Proposal #14: 9216-07-60
Ogema - Tomahawk
Culvert Replacement C-50-19
STH 86
Price County

This is Addendum No. 01, which provides for the following:

Addendum No. 01
 ID 9216-07-60
 Revised Sheet 5
 May 18, 2017

**Addendum No. 01
ID 9216-07-60
Revised Sheet 33
May 18, 2017**

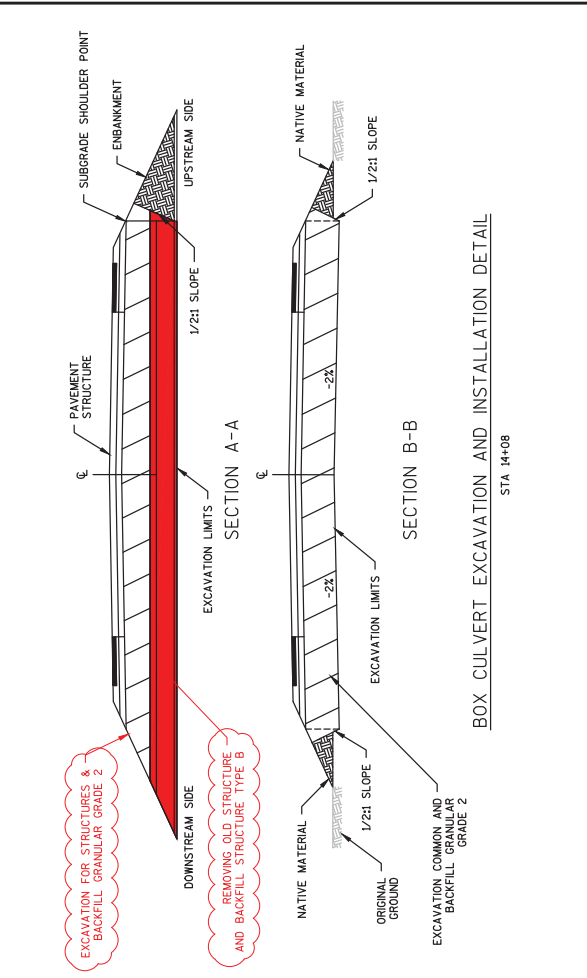
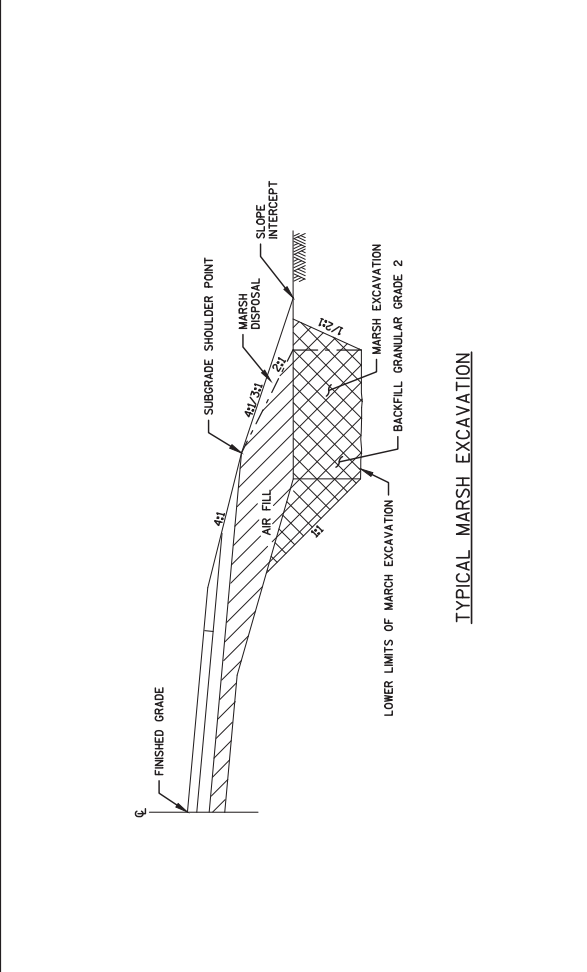
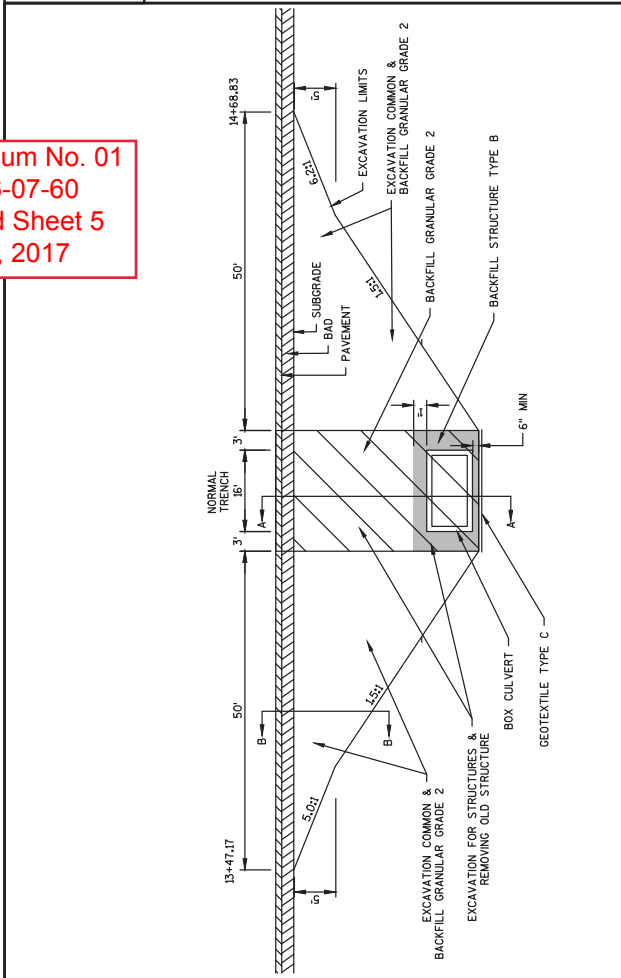
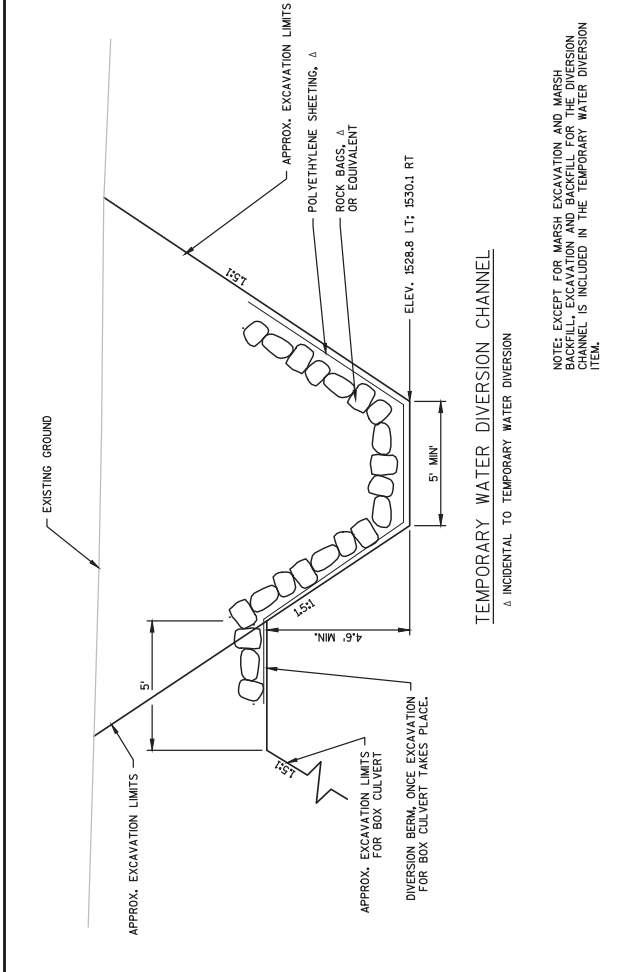
Revised Plan Sheets	
Plan Sheet	Plan Sheet Title (brief description of changes to sheet)
5	Construction Details (Modified Section A-A within the "Box Culvert Excavation and Installation Detail" to clarify excavation and backfill limits.)
33	Structure C-50-19 Box Details (Replaced backfill pay limit NOTE under GENERAL NOTES to clarify backfill requirements and Deleted backfill NOTE under GENERAL NOTES, as other modifications in Addendum No. 1 already clarify backfill items and limits.)
